SAFETY RECALL NOTICE

**NHTSA RECALL [25V571]
Orange EV RECALL [2025-SRC-06]**

This notice is sent to you in accordance with the National Traffic and Motor Vehicle Safety Act. Orange EV (OEV) has decided that a defect, which relates to motor vehicle safety, exists in certain 2024 - 2025 HUSK-e Tandem Terminal Trucks. Our records indicate that you are the current owner of a vehicle affected by this action.

EXAMPLES OF DRIVESHAFT CONTACT

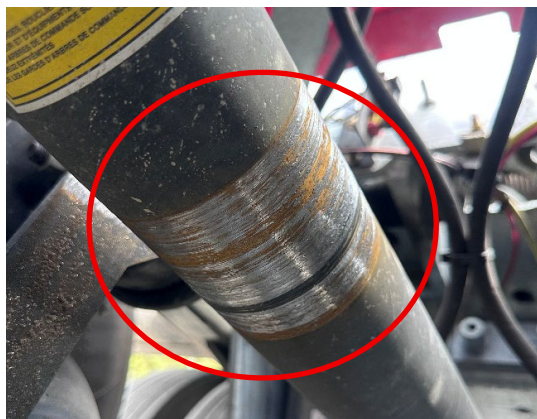
Due to a vehicle design issue, the driveshaft on the subject vehicles may make contact with other vehicle components. If this occurs, it can damage those components and can impact the vehicle's service and emergency braking system, both of which can increase the risk of a crash.

Please contact your Regional Service Supervisor to schedule your service. Until then, please verify that the walking beam suspension trunnion shear nuts are still fastened and inspect the driveshaft daily for signs of contact.

CHECK THE TRUNNION SHEAR NUTS AND INSPECT THE DRIVE SHAFT DAILY. IF EITHER NUTS ARE MISSING OR IF ANY DRIVESHAFT RUBBING IS OBSERVED, STOP USING THE TRUCK AND CONTACT YOUR REGIONAL SERVICE SUPERVISOR!

Orange EV will inspect affected trucks for signs of driveshaft contact and proper walking beam alignment. For trucks that pass inspection, OEV will replace the driveshaft, brake chamber, and suspension components, as necessary, **FREE OF CHARGE**. For Trucks that don't pass inspection, OEV will coordinate to have your truck transported to the manufacturing facility for driveshaft replacement and further axle alignment or replacement, **FREE OF CHARGE**. **The repair is expected to take between 1 and 8 hours, depending on the extent of the repairs.**
